Certificate of Appropriateness for
1207 Jenifer St.

June 24, 2019

Proposed Work

- Replace all windows and doors

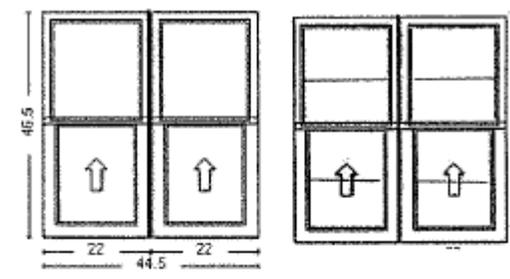
AW EXISTING WINDOWS FOR THE EXCEPTION OF BEST MATCH WINDOWS, WHICH ARE (2 VERTICAL MULLIONS)

NEW OLD

Staff believes that the standards for granting a Certificate of Appropriateness are not met due to the windows and doors potentially being repairable, and the proposed replacements not replicating the original features. As such, staff recommends that the Landmarks Commission deny the proposal.

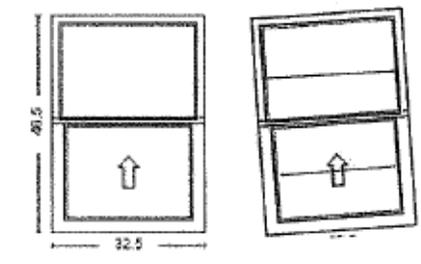
NEW OLD
